Confey Phase 1A LRD

RFI Response to Items 1, 4, 5, 6, 7, 8, 9, 10 &
12(c) KCC Reg Ref: 26/60746

2423-DOB-XX-SI-RP-C-0004

Figure 2 4.0m wide Active Travel Infrastructure proposed as part of the subject application (source: DOBA drawing 2423-DOB-XX-SI-DR-C-0500)

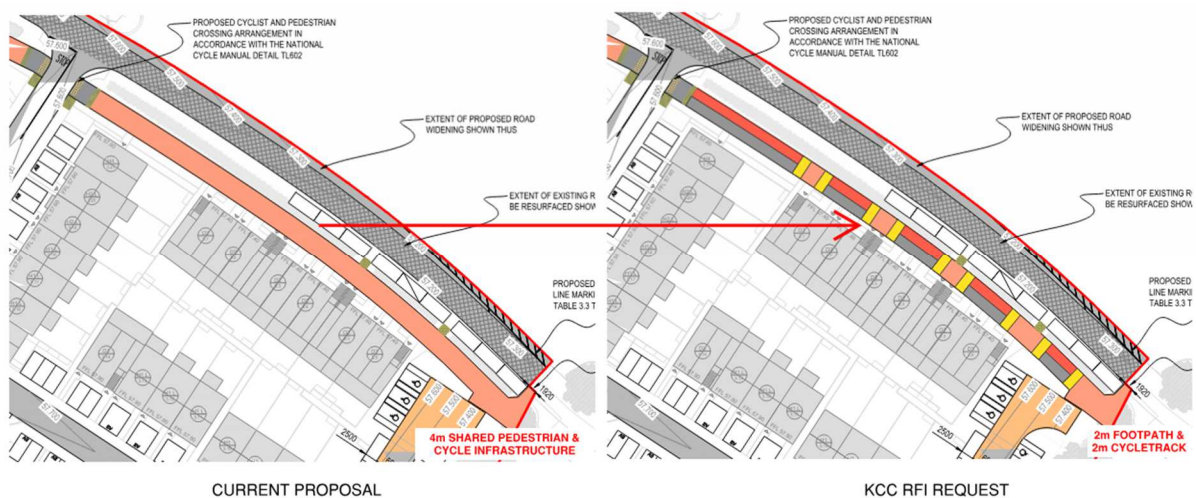
Please note that a 2.0m footpath and cycle path to be provided along L1015 as per Phase 1a of Confey Lands Masterplan and in line with the NTA submission is required. The Applicant is requested to resubmit a revised drawing indicating this requirement.

The proposed development, as part of the Phase 1A of the Confey Masterplan, provides for a continuous 4.0m wide shared pedestrian and cyclist infrastructure along the L1015 as illustrated in orange in **Figure 2** below in lieu of separate 2.0m wide footpaths and 2.0m wide cycle tracks and the reason for this is clear. If separate footpaths and cycle paths are provided, these will require tactile paving and shared surfaces to access the duplex units fronting onto the L1015 at unrealistic and impractical intervals as can be seen in the comparison in **Figure 2** below.

The pedestrian and cycle infrastructure surface shall be continued as part of the delivery of future phases of development along both sides of the L1015 in accordance with the Confey Masterplan. The Applicant is providing the pedestrian and cycle infrastructure relevant to Phase 1a as part of this phase.

Figure 3 Attenuation features & constraints at the outfall

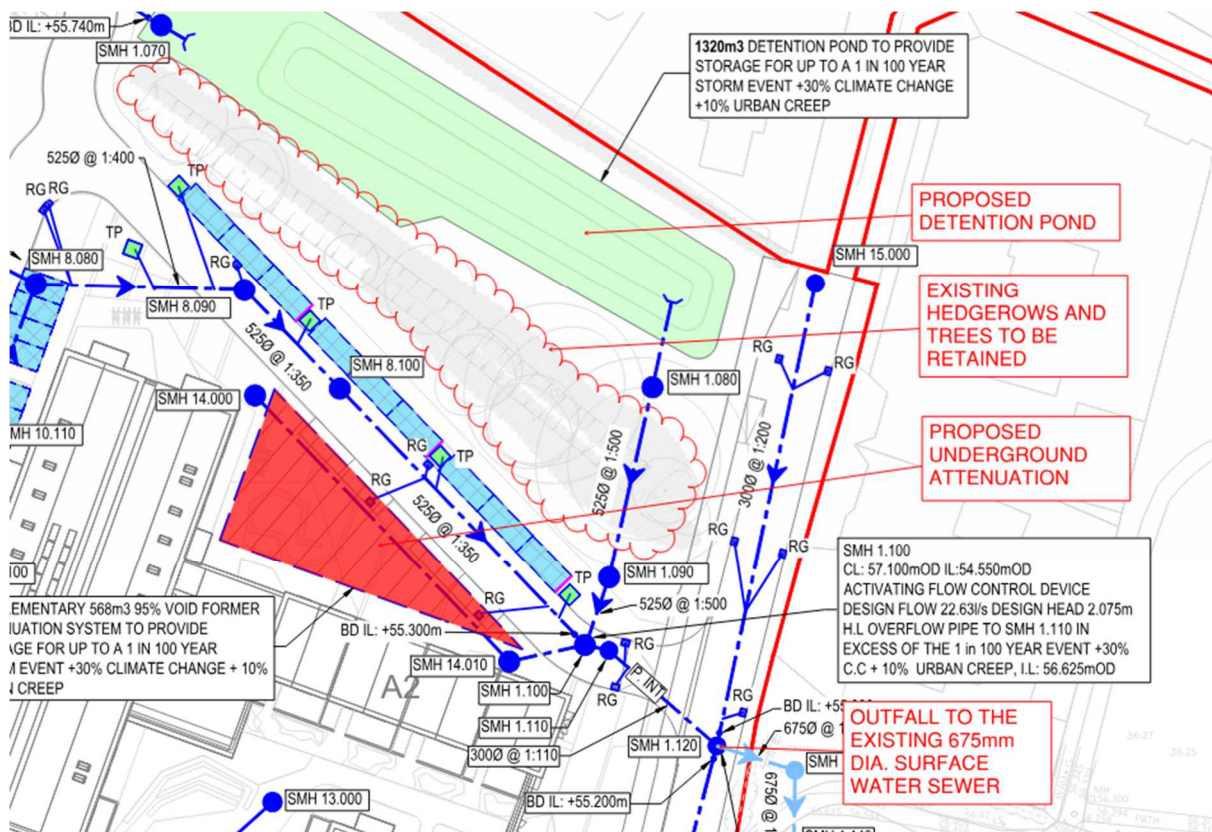
Notwithstanding the details submitted, it is noted that underground attenuation storage systems form part of the proposed development. Please note that it is the intention of Kildare County Council to remove underground surface water tanks (Kildare County Development Plan 2023-2029 Objective INO24). The surface water drainage design should include but not be limited to:

With regard to Development Plan Objective IN O24, we note that the site-wide surface water management strategy has been designed to prioritise the use of above-ground Sustainable Drainage Systems (SuDS), such as detention systems, swales, Bio detention basins, Bioretention Areas, supplemented by below-ground filtration systems such as filter drains, permeable paving and tree pits etc. In this instance, an overall storage volume of 3526 cubic meters is proposed throughout the development where a small portion of this volume (less than 19%) of the overall storage is proposed in the form of supplementary underground attenuation. As can be seen from **Figure 3** below which is an extract from the DOBA Proposed Surface Water drainage layout drawing 2423-DOB-XX-SI-DR-C-0200, the provision of attenuation is constrained at this outfall location by the requirement to retain the existing trees and hedgerow. If these were removed, the proposed detention pond could be enlarged to the south and the proposed attenuation tank located beneath the plaza area to the north of the neighbourhood centre could be removed. As it stands, it would not be appropriate to provide an open water feature in-lie of the underground attenuation system.

The design solutions and proposals to try and completely omit any underground attenuation on the site have been exhausted as noted above. The constraints noted in addition to the site levels, outfall levels, and the requirement to accommodate storage for all events up to a 1 in 100 year + 30% Climate Change event plus additional 10% Urban Creep factor through the site all factor in the attenuation provision.

The proposed surface water management strategy remains compliant with the Kildare County Council Sustainable Drainage Systems guidance and the KCC Development Plan IN O24 where it **does not omit underground attenuation** from being accepted, but only where all other solutions have been explored, which is the case for the proposed development. IN O24 of the KCC Development Plan States the following; *"Only consider underground retention solutions when all other options have been exhausted."*

Figure 4 Proposed Typical Sub-Catchment Treatment Train

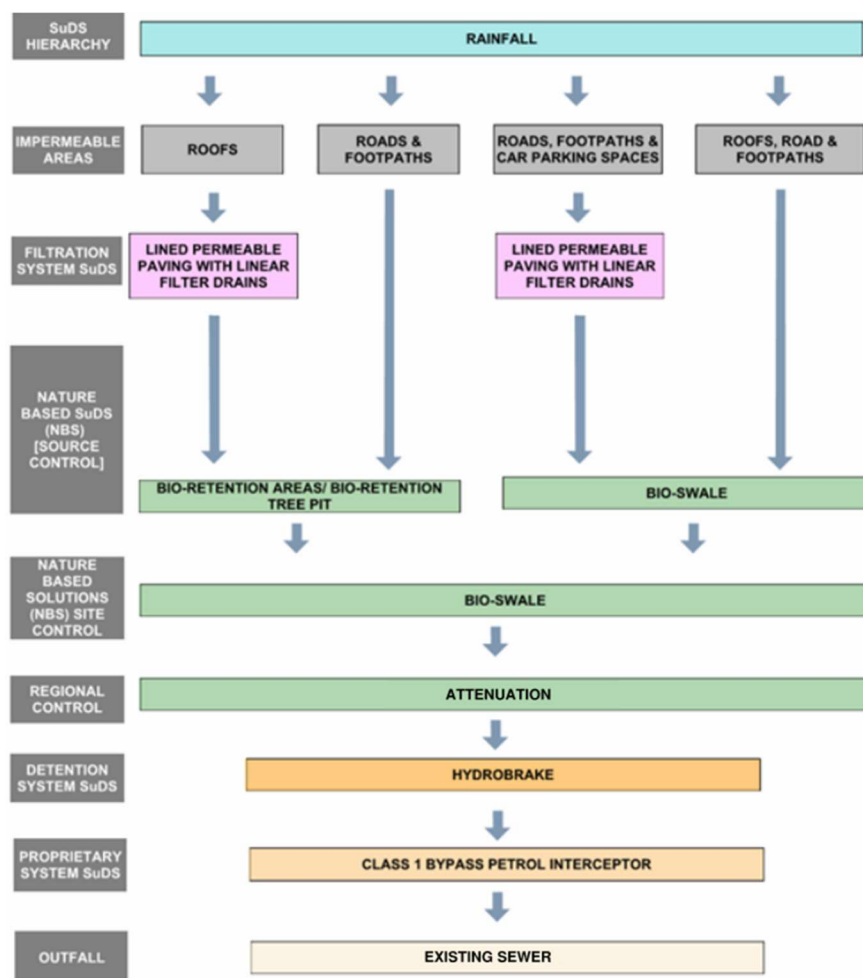
- d) The appropriate level of treatment for all runoff leaving the site.*
- e) Detailed engineering drawings of each component of the drainage scheme.*

The proposed design provides a **minimum** 2-stage surface water treatment process which intercepts surface water run-off at source and treats the water by filtration and treatment through natural material prior to discharging to the existing surface water network traversing the GAA club to the east prior to discharging to an existing Oranstown watercourse. **Figure 4** below is an extract from the DOBA Infrastructure Design Report (IDR) report 2423-DOB-XX-SI-RP-C-0001 which was submitted as part of the planning application documentation illustrating the proposed treatment train.

Figure 6 Flow of Oranstown stream beneath the Canal (source: <https://gis.epa.ie/EPAMaps/Water/>)

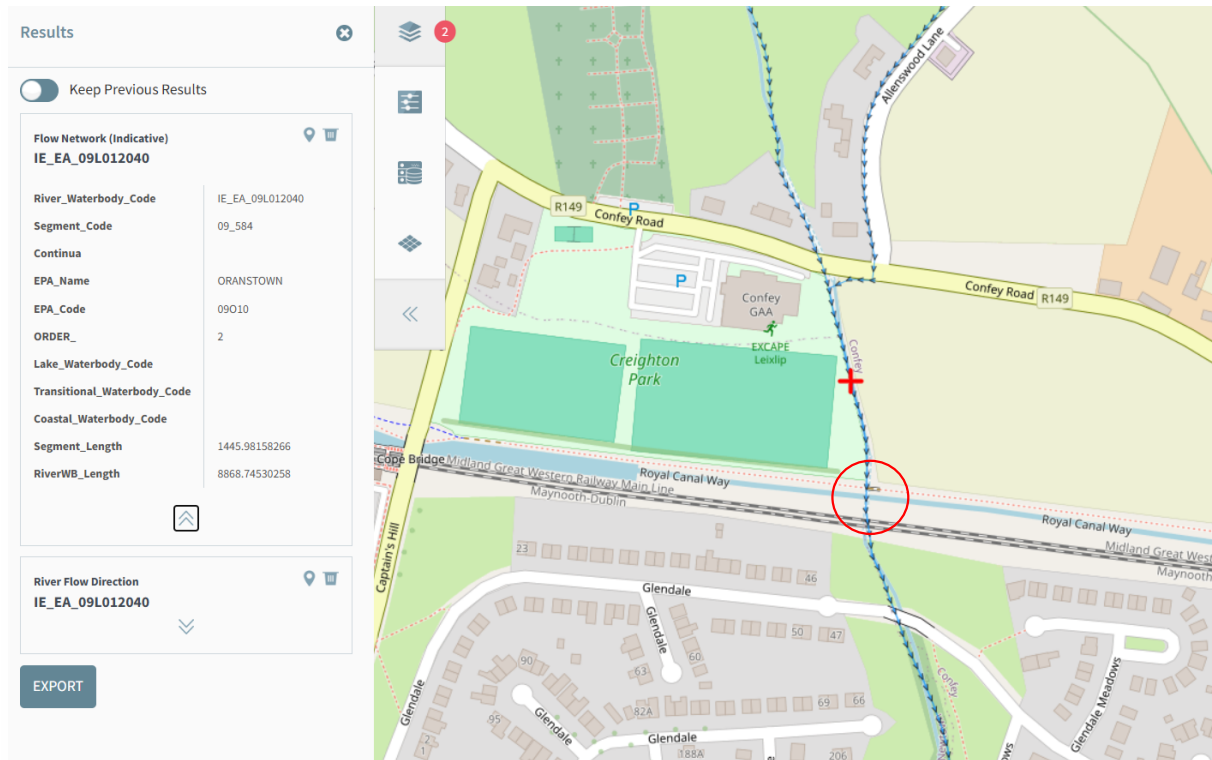
Please note that written consent is required from Waterways Ireland for the proposed surface water discharge from the development to the Oranstown stream. The Applicant is advised to obtain written consent and to submit a copy of this consent to the Planning Authority.

Secondly, the existing site drains to the Oranstown Stream via the existing 675mm dia. surface water sewer beneath the Confey GAA lands. The existing Oranstown Stream does not discharge to the Canal as evident via an extract from the EPA river flow network in **Figure 6** below. The proposed development is simply discharging flows through this existing connection and written consent is therefore not required. Thirdly, the proposed discharge has been reduced to pre-development greenfield rates, therefore, this is no additional flow from the proposed development compared to the existing. Additionally, the Applicant liaised with Waterways Ireland and as per the DOBA IDR submitted as part of the original planning application, Waterways Ireland has no objections to the same.

Figure 7 Comparison of a typical example of table top/ ramped infrastructure revised to avoid impeding residential access or conflict with ramped slopes (source: DOBA Pr. Site Layout Revision P.10 versus P.11)

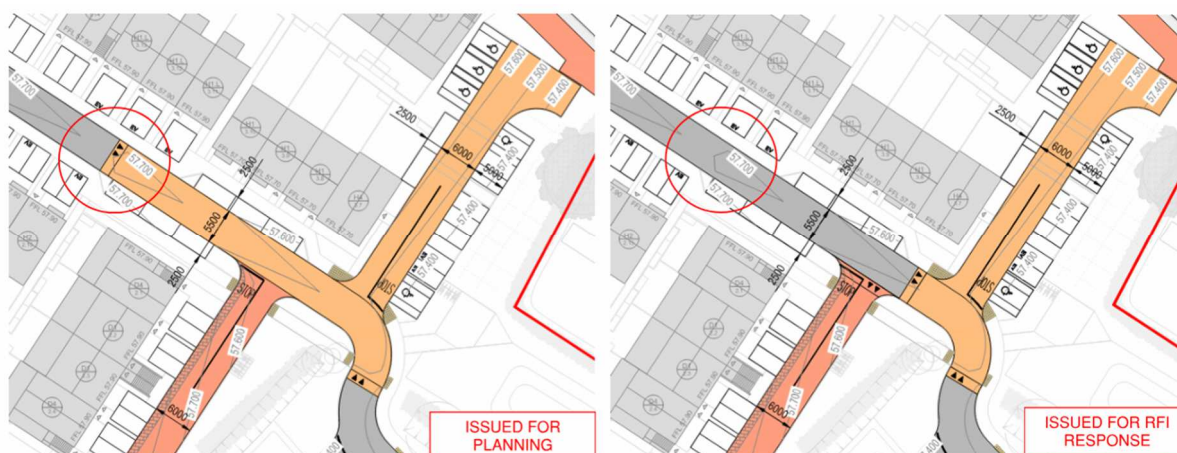
The Applicant is requested to review the positioning of road/ tabletop ramps to ensure that no residential access to driveways is impeded or conflicts with ramp slopes.

The Applicant has amended the Proposed Road Layout Plan with particular attention to the positioning of the tabletop/ ramped infrastructure to ensure that no residential access is impeded or conflicts with the ramped slopes. DOBA drawing 2423-DOB-XX-SI-DR-C-0500-S2.P11 Pr.Site Layout has included in **Appendix H** of this report and a comparison of the planning issued and updated RFI response layout are presented in **Figure 7** below.

Figure 2.1 – Locations of Where Cyclists Will Be Required Transition Back into Traffic Lanes

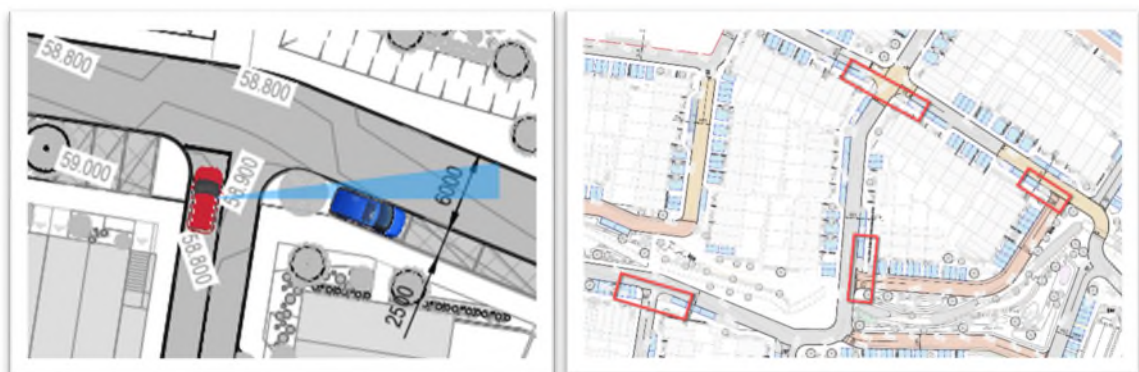
When cyclists reach the end of the segregated cycling tracks, they will merge into adjacent traffic lanes unexpectedly, which could increase the risk of them being struck from behind by approaching vehicles.

Cyclists should be provided with a safe and appropriate means to transition back into the adjacent traffic lane. The measures should highlight to drivers the location where cyclists will be re-entering the traffic lane in front of them.

2.1	YES	YES	<p>Along the East of the site, a transition arrangement in accordance with The Cycle Design Manual is provided in the interim, prior to the completion of the Confey Masterplan and associated future road upgrade. Upon completion of the masterplan, dedicated cyclist and pedestrian facilities will be developed further.</p>  <p>Similarly, In the Interim and prior to the Confey Masterplan being completed, a shared surface with tactile paving and dropped kerb is provided for a transition to the carriageway.</p> 	Comment noted.

Figure 2.4 – Missing Footpath Links Near Main Pedestrian Access to Captains Hill / Train Station

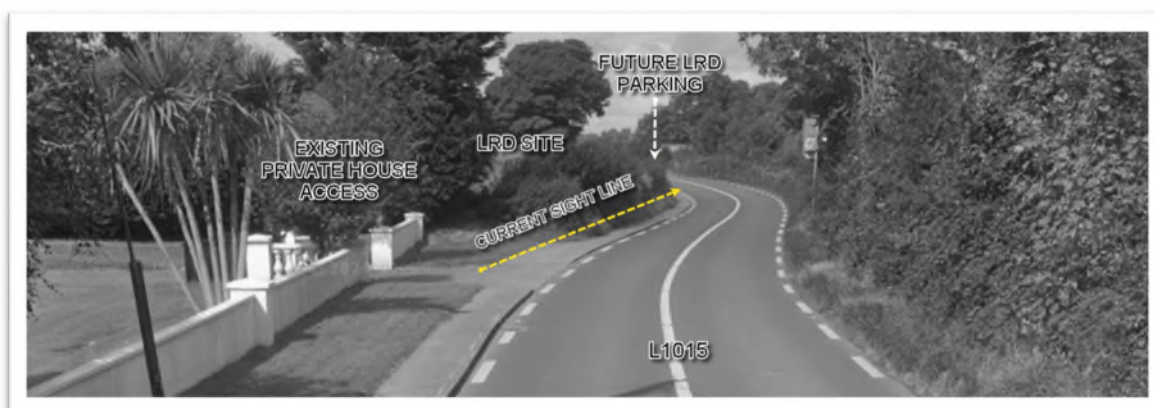
The absence of suitable footpath connections here could lead to pedestrians stepping into the adjacent traffic lane without warning. It could also lead to slips and trips for pedestrians attempting to walk in the grass to reach the nearest available footpath connection.

Suitable footpath links should be provided here, including raised crossings where required.

Problem Reference (Section 2)	Designer Response Section			Audit Team Response Section
	Problem Accepted (yes / no)	Recommended Measure Accepted (yes / no)	Alternative Measures or Comments	Alternative Measures Accepted (yes / no)
			<p>given the slower speeds through the internal road network</p> 	
2.3	YES	YES	<p>Additional Pedestrian Crossing points have been added where pedestrians will cross internal streets.</p> 	Comment noted.
2.4	YES	YES	<p>Landscaped connection has been provided from the units to the eastern portion of the site</p> 	Comment noted.
